**PREVOST**

**WARRANTY  
BULLETIN**

Wb98-33

DATE :	October 1998	SECTION :	22, HVAC
EXPIRATION :	October 1999		
SUBJECT :	A/C SYSTEM MODIFICATIONS

**Figure 2:** Shaded parts: existing filter dryer and hoses to be removed and discarded. **Items 1 to 3 :** hoses to be fixed on the new filter dryer assembly; **Item 4:** moisture indicator assembly to discard

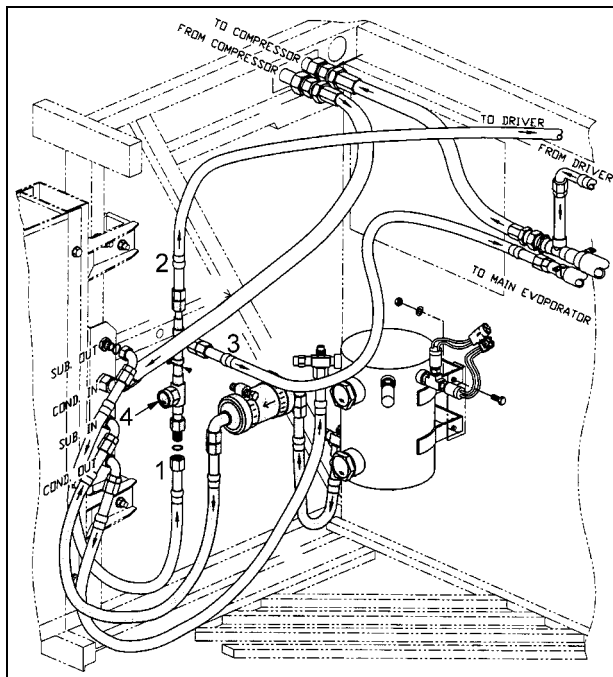
6. Disconnect hoses 1 to 3 of figure 2. Remove and discard the moisture indicator assembly shown on figure 2, item 4;

7. Install new assembly shown on figure 3 to hoses 1 to 3 of figure 2;

**Figure 3:** Front view of the liquid solenoid valve new assembly.

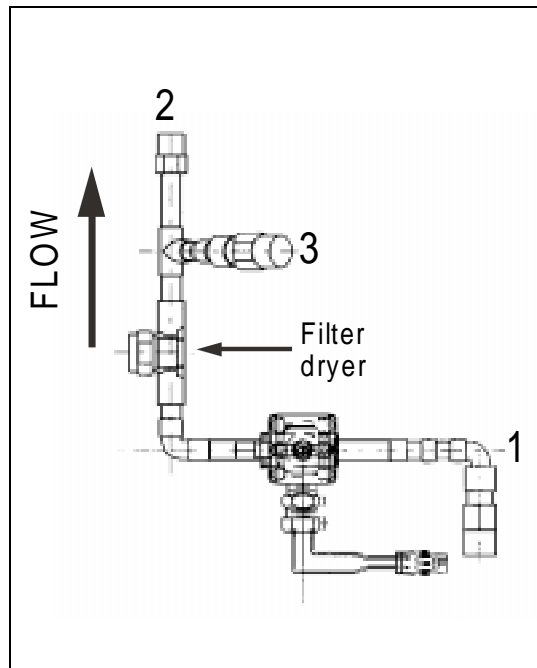
**Note:** Since the subassembly lower part interferes with receiver tank, turn the pipe 90° downwards as shown on figure 3, item 1.

**Figure 4:** (1) Condenser compartment's metallic structure; (2) New bracket fixed at 24 in (613 mm) below compartment's veneer top.

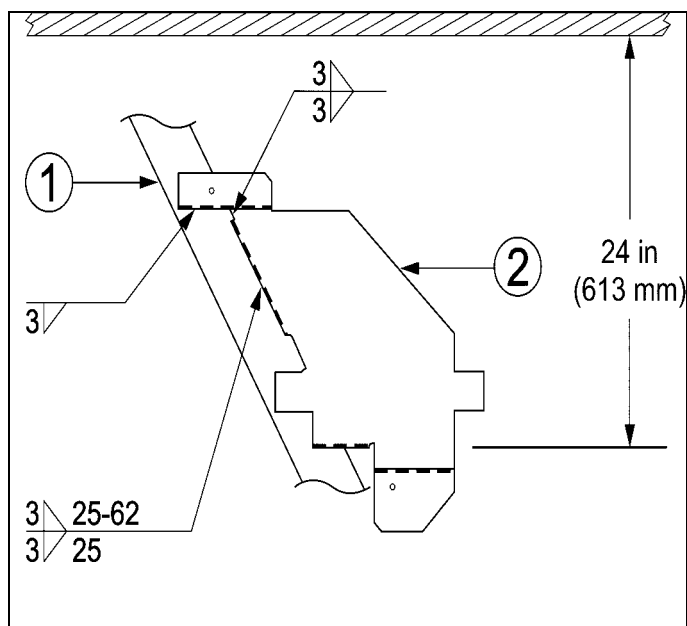
4. Remove existing filter dryer support;
5. Install bracket #213752 on the left-hand side of the compartment. As shown on figure 4, the bracket should be welded on the metallic structure at 24 inches (613 mm) below the veneer top of the compartment. It is recommended to use a semi-automatic electric arc welding in accordance with the following specifications:

- GMAW (Gas Metal-Arc Welding) process;
- welding wire conforms to AWS (American Welding Standards) A5.9 specifications;
- 308L type welding wire with 0.035" diameter (0,9 mm);
- voltage: 18 volts to 22 volts;
- current: 50 amperes to 200 amperes;

- shielding gas: T90-H (90% helium, 7,5% argon, 2,5% CO<sup>2</sup>).

**Figure 5:** Final aspect of the assembly. New hose #452383 (in gray).

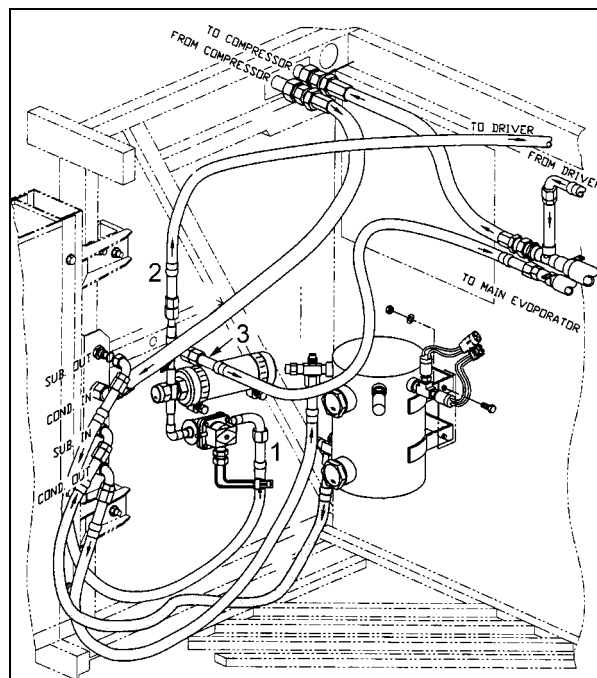
8. Connect filter dryer on the new liquid solenoid valve assembly. The result of these steps is presented on figure 5;

**Figure 6:** Before and after the installation of the new solenoid valve assembly.

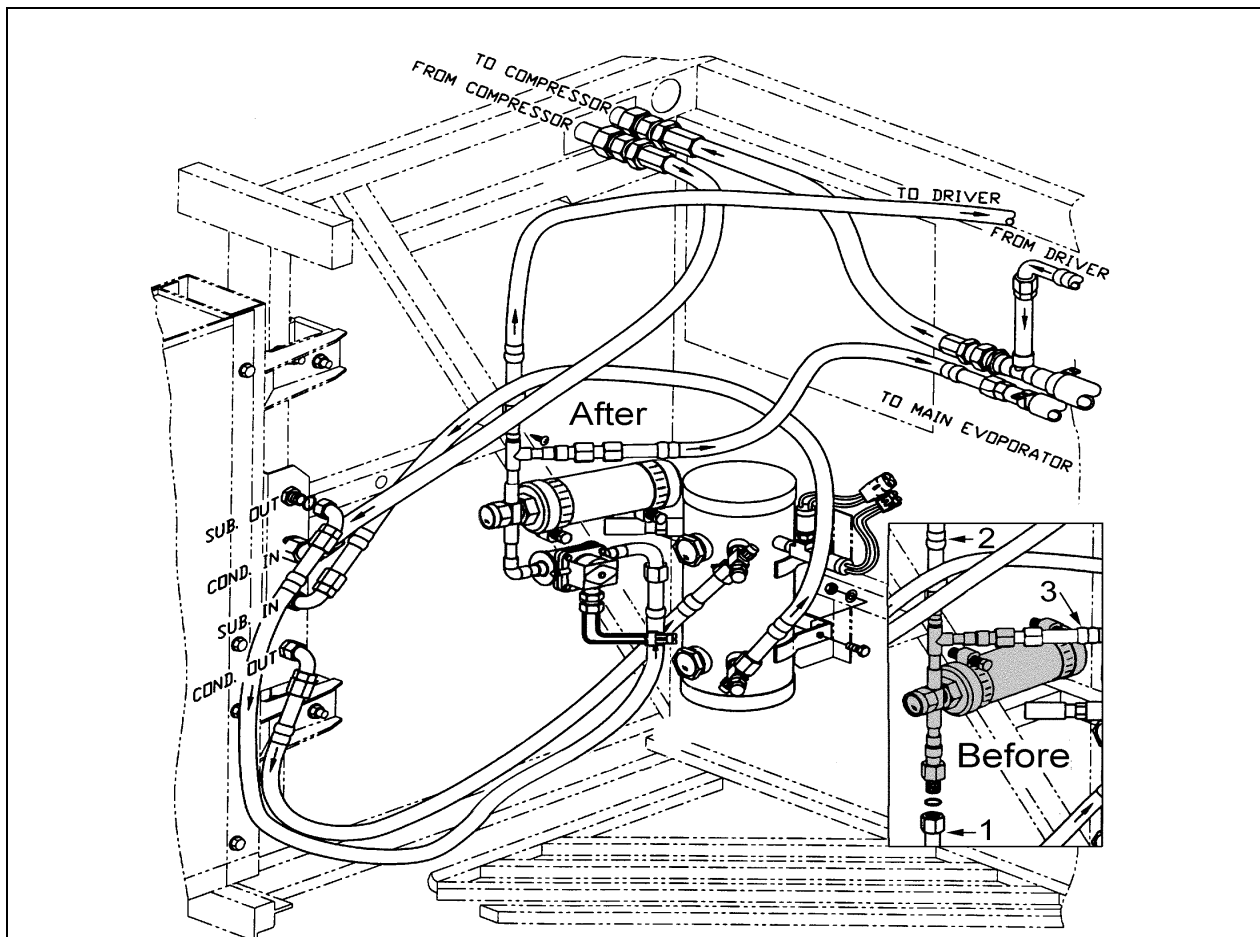
5. Connect filter dryer on the new liquid solenoid valve assembly as presented on figure 3. The result of these steps is presented on figure 6;
6. Affix foam tape #506466 on the bracket, in order to reduce vibrations;
7. Now that the liquid solenoid valve new assembly has been properly installed, go to the section called **Liquid Solenoid Valve Electrical Connection** that applies to your vehicle's serial number (page 9 or page 11).

**Figure 7:** Front view of the new bracket. (1) Bandsaw pattern.

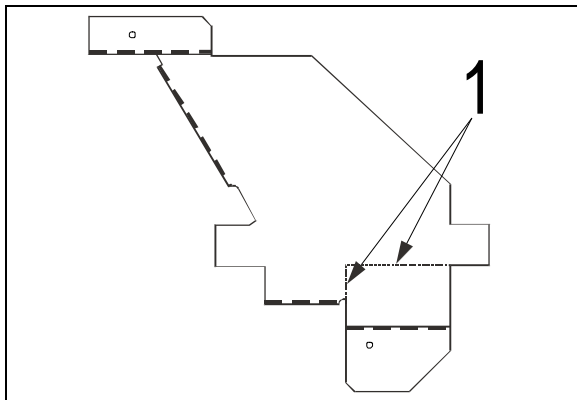
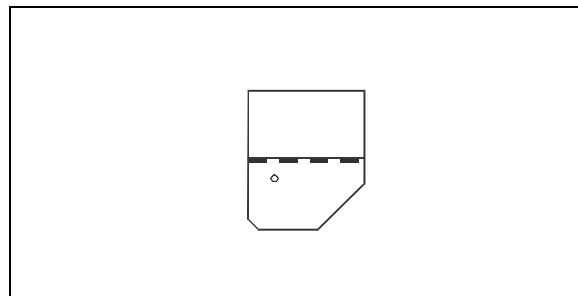
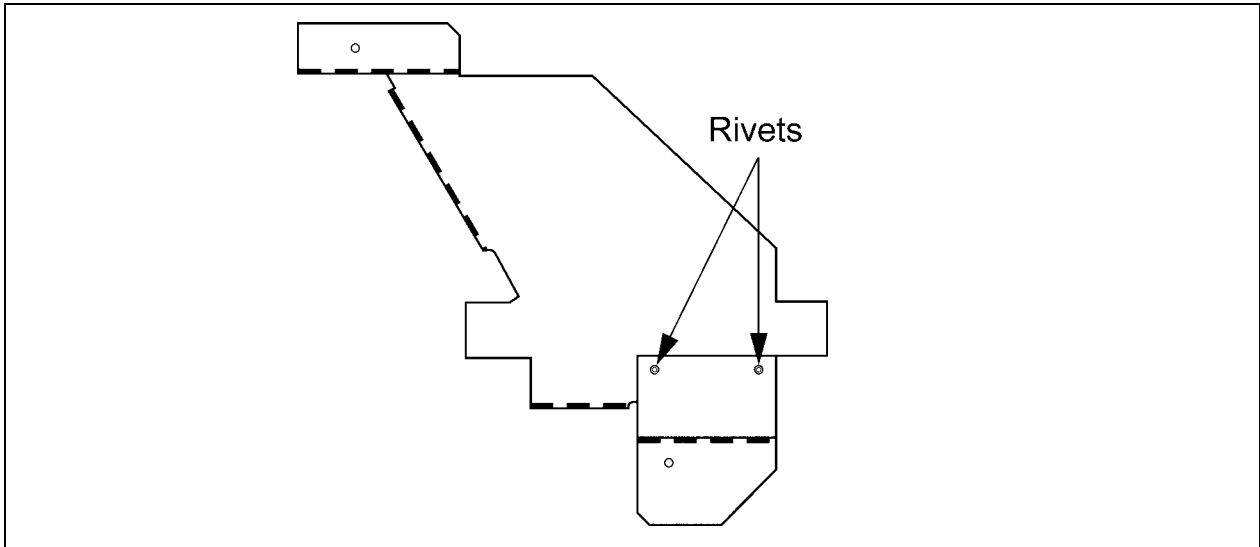
**METHOD 2:** Using a bandsaw, cut the new bracket on figure 7 dotted lines. Keep the portion shown on figure 8. Rivet this bracket portion on the existing bracket, as presented on figure 9.

**METHOD 2:** Using a bandsaw, cut the new bracket on figure 7 dotted lines. Keep the portion shown on figure 8. Rivet this bracket portion on the existing bracket, as presented on figure 9.

**Figure 10:** Condenser compartment. Before and after the installation of the new solenoid valve assembly.

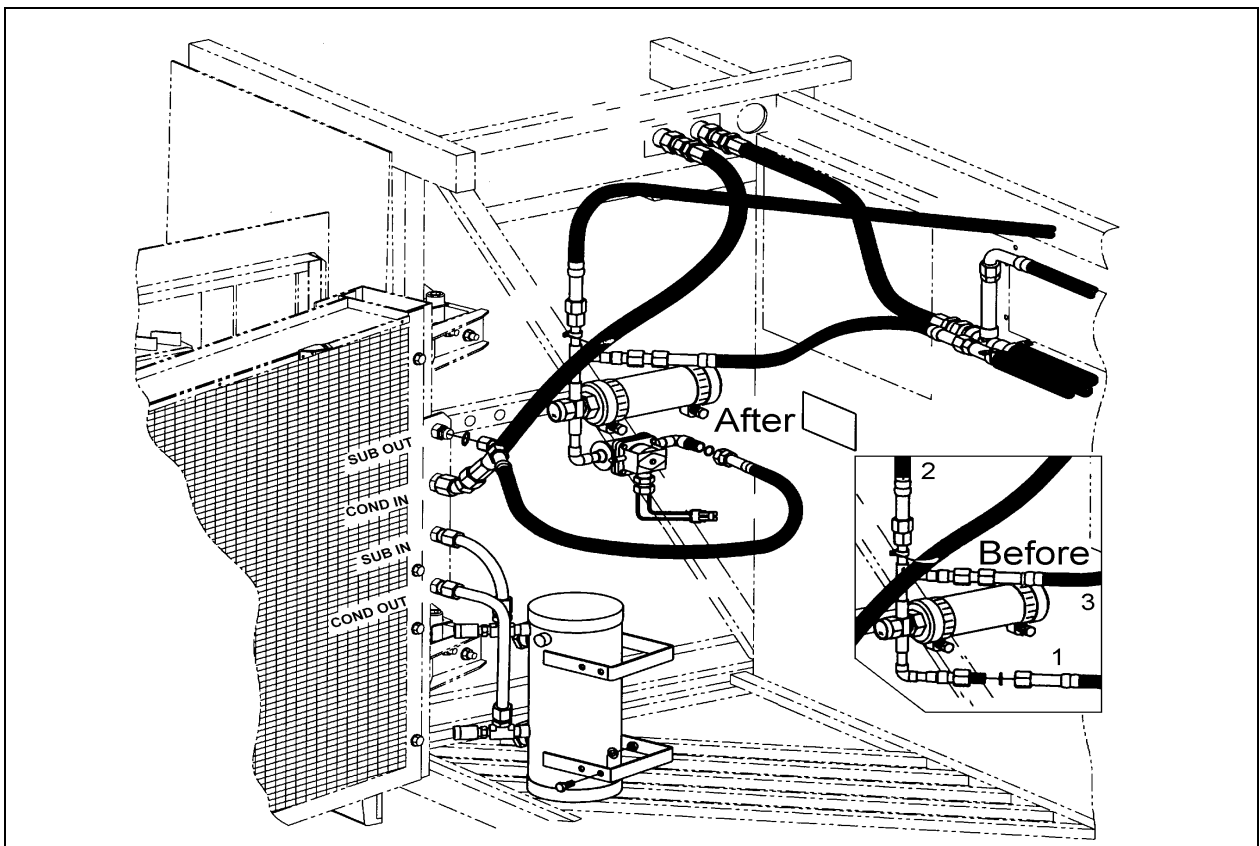
5. Affix foam tape #506466 on the bracket, in order to reduce vibrations in between bracket and dryer filter;
6. Fix filter dryer assembly. Make sure the proper connections are made. Refer to figure 10 for further details;
7. Go to page 11, 13 or 15 for details about liquid solenoid valve electrical connection.

**Figure 11:** Condenser compartment: (1) Ground; (2) Wire going to solenoid valve; (3) #064934 Cable; (4) C158 Connectors; (5) Receiver Tank; (6) A/C Junction Box.

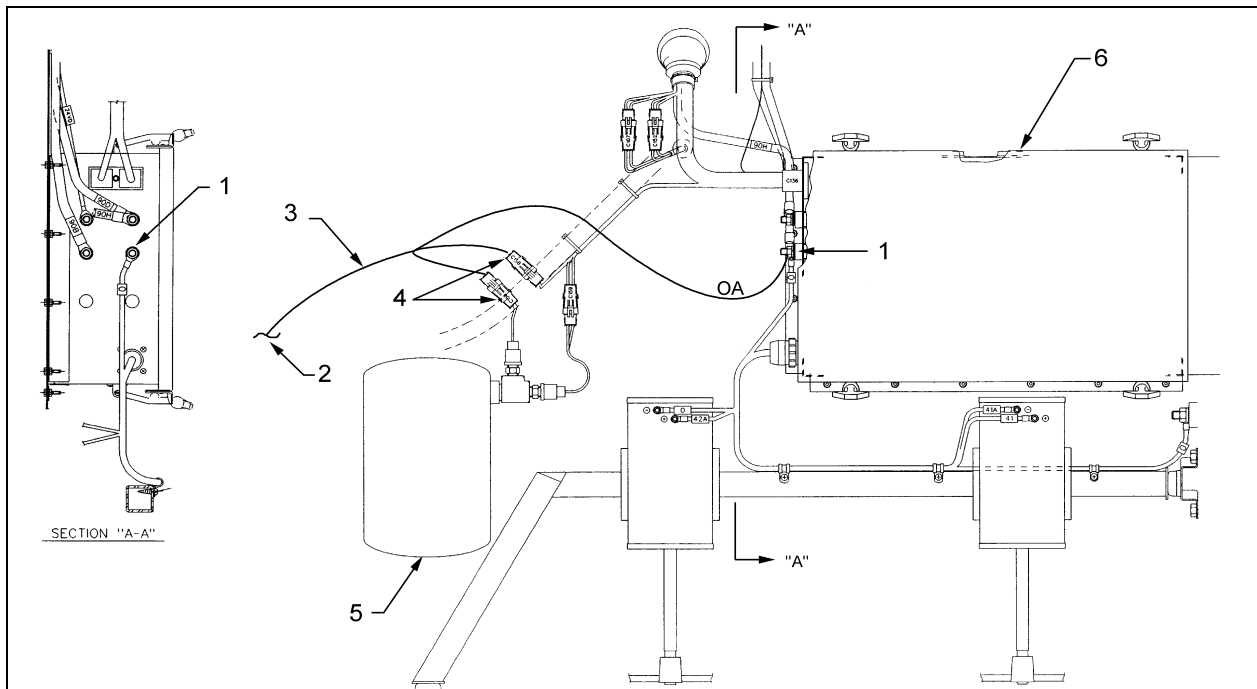
1. Open the condenser compartment (see figure 1);
2. Locate C158 connectors and the receiver tank (items 4 and 5 on figure 11);
3. Unplug C158 connectors and plug on each of them the connectors pertaining to #064934 cable (item 3 on figure 11);
4. Connect OA terminal to the ground located above two circuit breakers, on the left side of the A/C junction box (see sectional view A-A on figure 11);
5. Connect terminal #2 of figure 11 to the liquid solenoid valve connector;

6. Locate the A/C junction box in the condenser compartment (see item 6 on figure 11) and remove the lid;
7. Remove and isolate the two 2B wires from Cool 2 and Cool 3 commons (see figure 12) of the A/C control panel;
8. Remove 77B wire from terminal 87 of R36 relay. Isolate with a heat shrinking tube (item 2, figure 13) and connect to 064933 cable (item 1, figure 13);
9. Connect 77B wire of 064933 cable into terminal 87 of R36 relay (see figure 13);
10. Connect the other terminals to Cool 2 and Cool 3 commons on the A/C Control panel as shown on figure 13;

Figure 15: Rear electrical compartment. (1) Cable to cut coming from thermostat ; (2) Two C139 connectors to unplug and discard.

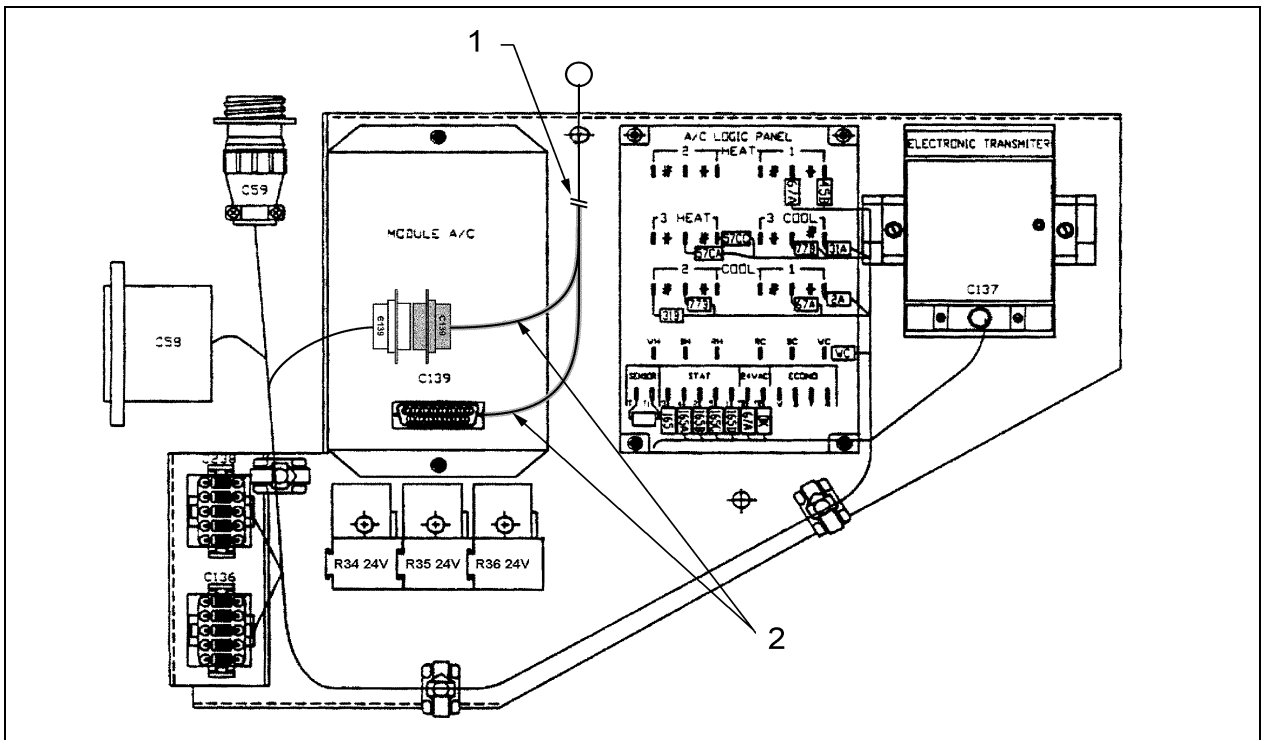
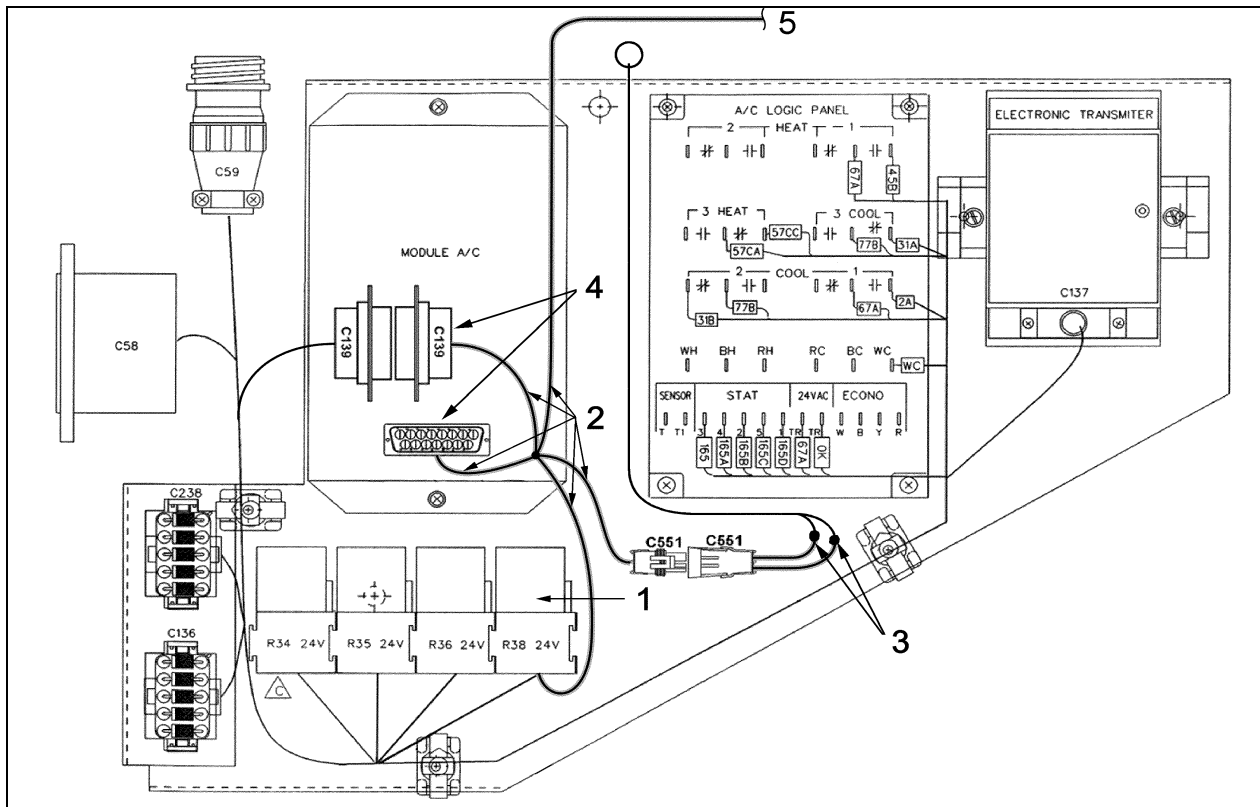
2. Cut 67A and 67M wires coming from thermostat, as shown on figure 15, item 1. Unplug and discard the two C139 connectors located on the A/C module and on the vehicle's wiring (item 2, figure 15) ;

**Figure 16 :** Rear electrical compartment. (1) R38 Relay; (2) 064931 Cable; (3) Welding; (4) C139 Connectors; (5) 2B wire.

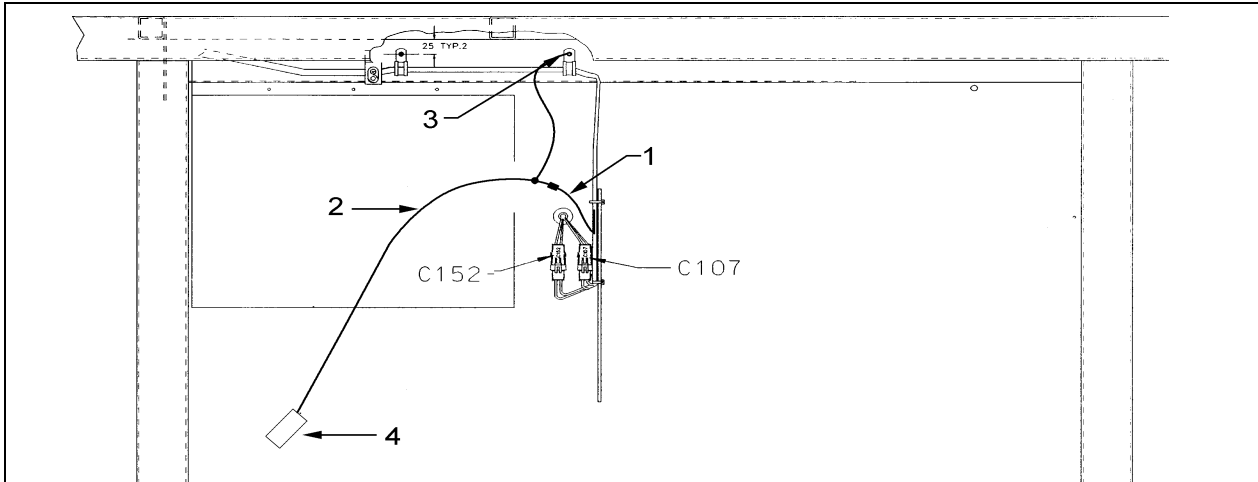
3. Fix new R38 relay base on the A/C junction panel, next to R36 relay. This base belongs to 064931 cable (item 2, figure 16);
4. Fix R38 relay on its base (item 1, figure 16);
5. Replace the connectors removed on step 2 with 064931 cable's proper connectors (item 4, figure 16). Use cable ties to secure the connection and avoid any vibration effect;
6. Locate C551 connector of 064931 cable. Cut this connector's jumper and weld each wire coming from the thermostat (67A and 67M) to both jumper wires (item 3, figure 16);
7. Identify spare wire SP92 located near C52 connector in the rear electrical compartment. Crimp and heat 2B wire (item 5, figure 16) with SP92 wire;

**Figure 17:** Condenser compartment final aspect: (1) SP92 wire; (2) 064932 cable; (3) Ground OA; (4) C95 Connector.

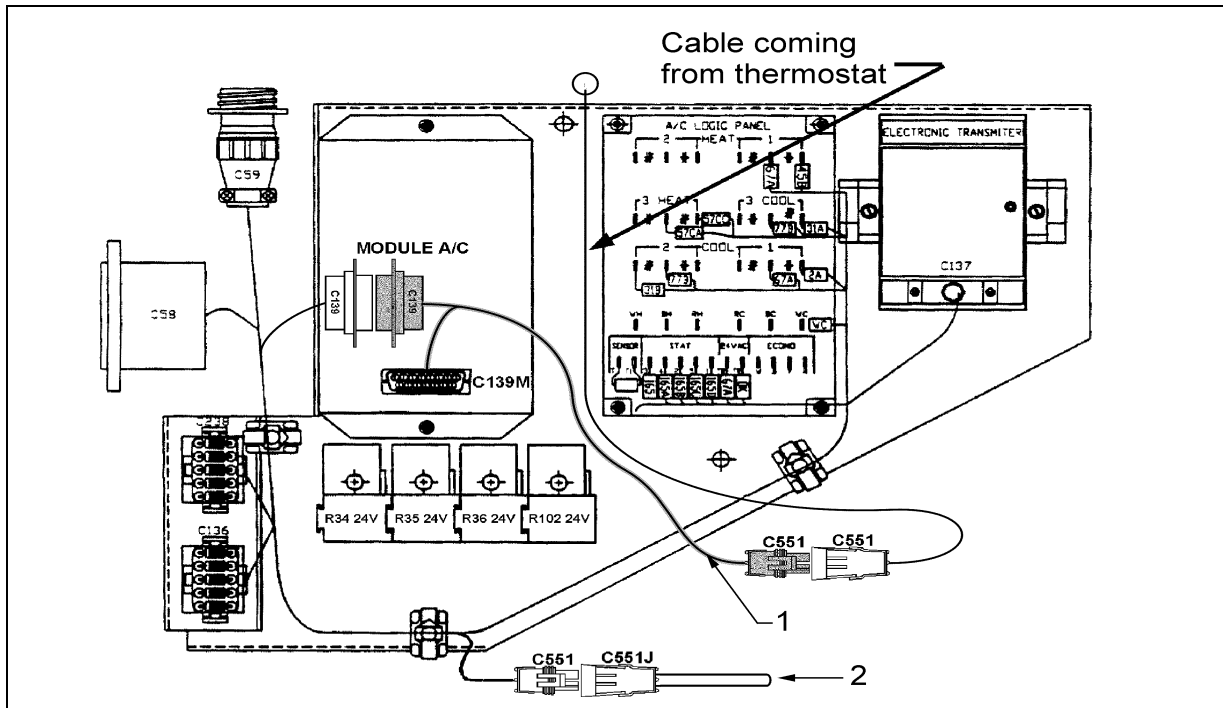
8. Open the condenser compartment (figure 1);
9. Plug 2B wire of 064932 cable on SP92 (item 1, figure 17) then crimp and heat;
10. Connect 0A terminal of 064932 cable on a stud as shown on figure 17, item 3;

11. Plug C95 connector (item 4, figure 17) of 064932 cable on the liquid solenoid valve connector;
12. It is suggested to perform the whole Warranty Bulletin before refilling the A/C system with refrigerant. Refer to your vehicle's Maintenance Manual to obtain more information about the solenoid valve Manual Bypass ( section 22, paragraph 10.6.2);
13. Refer to page 15 to know the Warranty reimbursement conditions.
